Re: Grissom Road Business Park

MDP # 006-07

The City Staff Development Review Committee has reviewed Grissom Road Business Park Master Development Plan **M.D.P. # 006-07**. Please find enclosed a signed copy for your files. Your plan was approved for acceptance; however please note the following conditions:

# GRISSOM ROAD BUSINESS PARK MASTER DEVELOPMENT PLAN

**MASTER DEVELOPMENT PLAN**

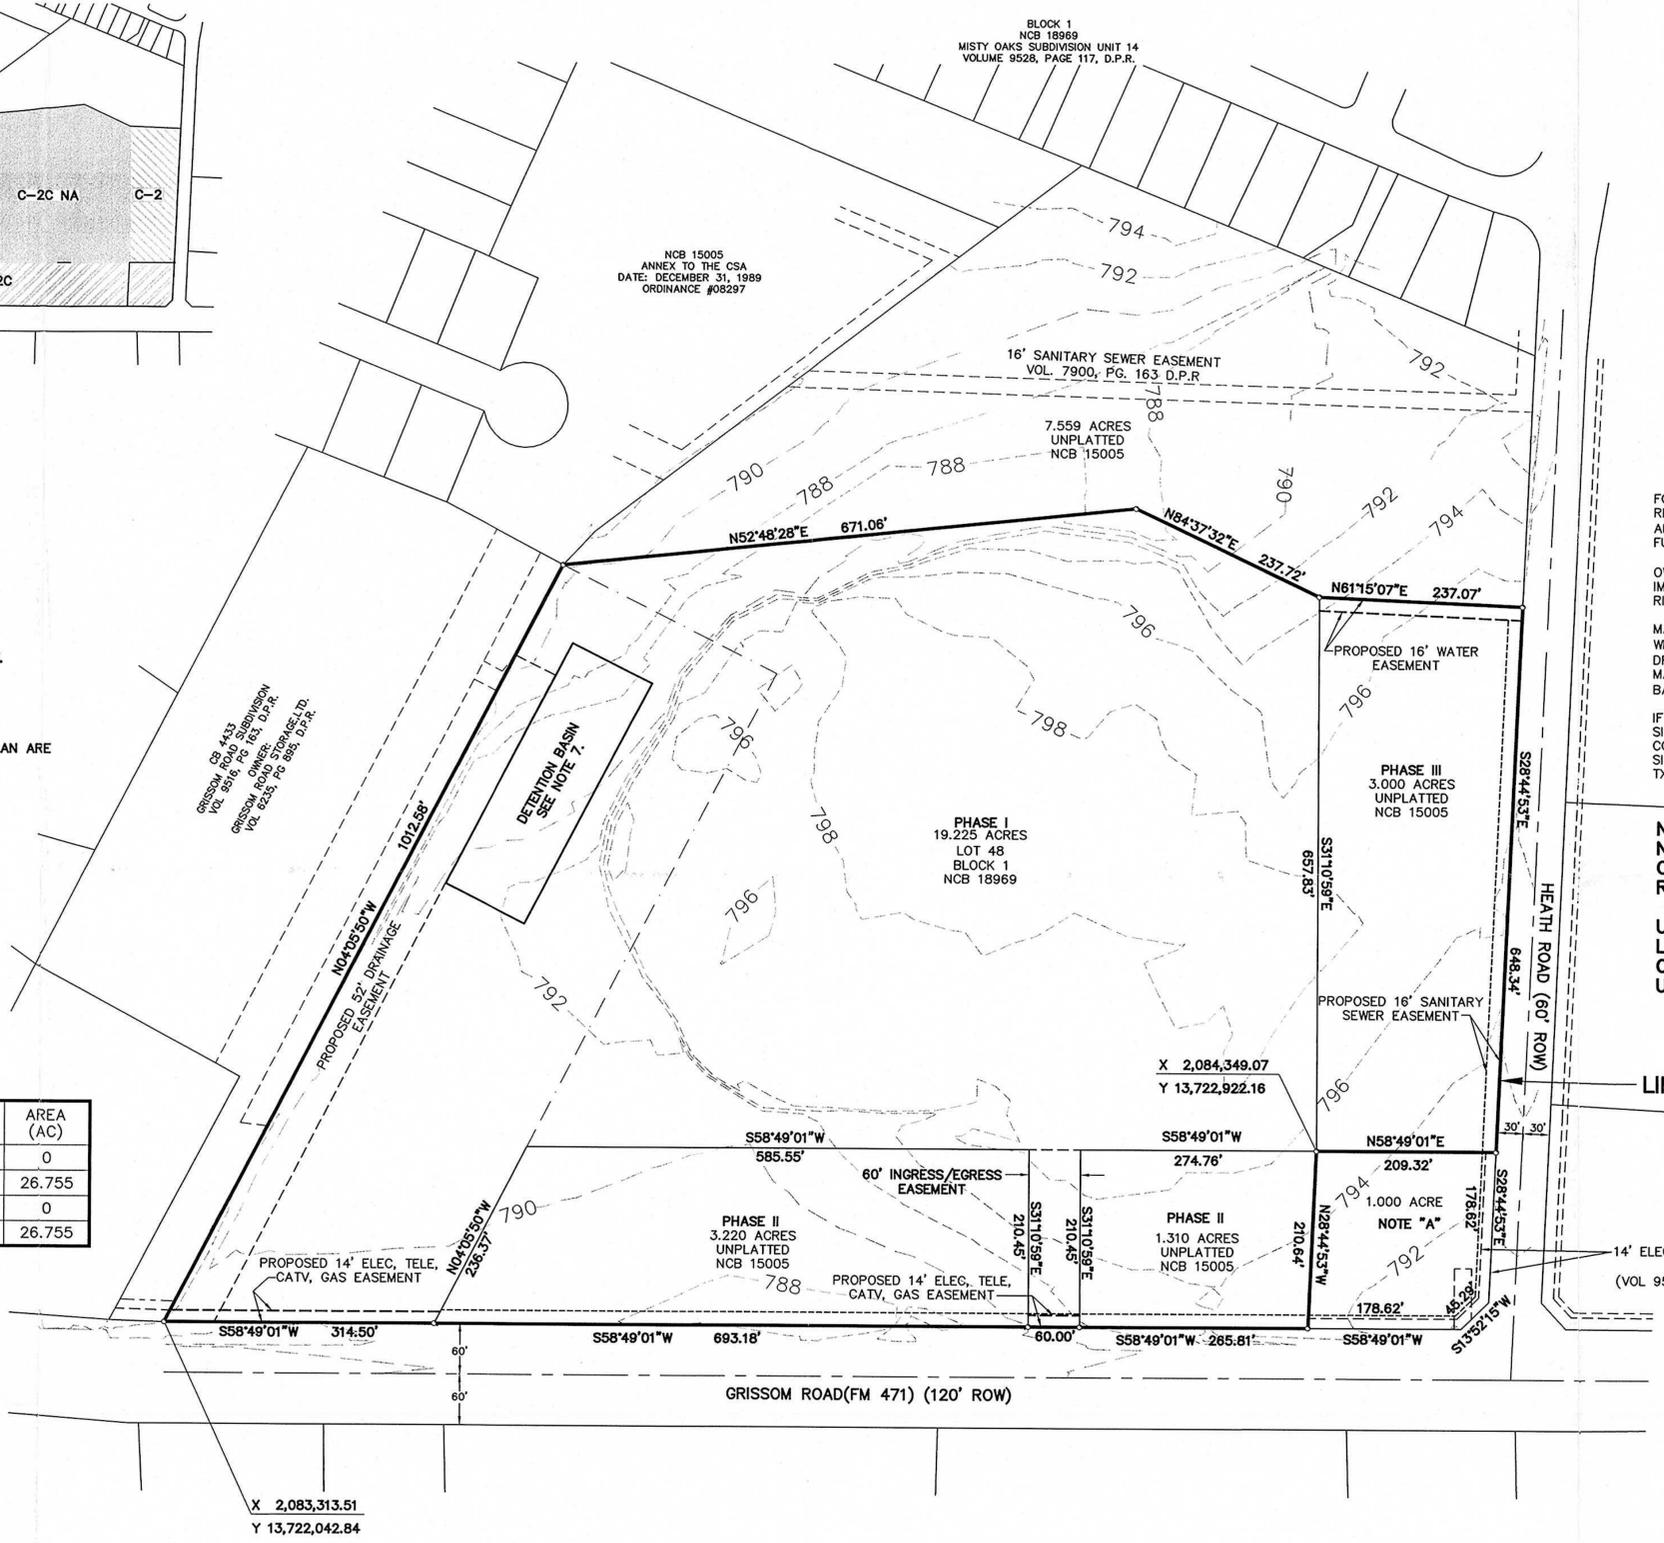
In consideration of public safety and convenience, excessive grades by reason of topography should be avoided in street layouts and arrangements. Any access and R.O.W. issues along state facilities will need to be resolved with the **Texas Department of Transportation (TXDOT)**. For information about these requirements you can contact TXDOT at 615-5814.

**DSD – Traffic Impact Analysis & Streets** indicate that under the UDC listed below are some of the requirements and onsite improvements that are necessary and shall be provided by the developer, on and before the completion of Grissom Road Business Park MDP, at no cost to the City of San Antonio:

- All access driveways shall comply with UDC 35-506(r)
- All roadways shall conform to Table 506-2 Functional Classification System Description for Traditional Design Classification.
- All sidewalks shall comply with UDC 35-506 (q).
- All access roadways shall provide clear sight distance on all existing and proposed roadways in order to provide adequate obstruction free viewing distances for approaching traffic. All signage, landscaping, and improvements shall be selected and located so as to not block these clear sight distances areas.

**Tree Preservation** approves with the following conditions:

- 2003 Tree Preservation ordinance standards per UDC Section 35-523 – a Tree Preservation Plan has been approved under for this project – AP 1148085.
- Landscape ordinance per UDC Section 35-511. Some landscape points might be met by preserving existing vegetation (either through preservation of smaller material or transplanting). Recommend securing knowledgeable Landscape Architect at planning and design phase to better utilize existing trees and vegetation. Preservation will eliminate the need for irrigation. Staff would be willing to meet with developer at design stage to assist with tree preservation and landscape plan.

- A soil assessment shall be submitted to the Texas Commission on Environmental Quality before any permits for development of the site in accordance with rule §330.953 of the Texas Administrative Code to determine if the site is a former landfill.
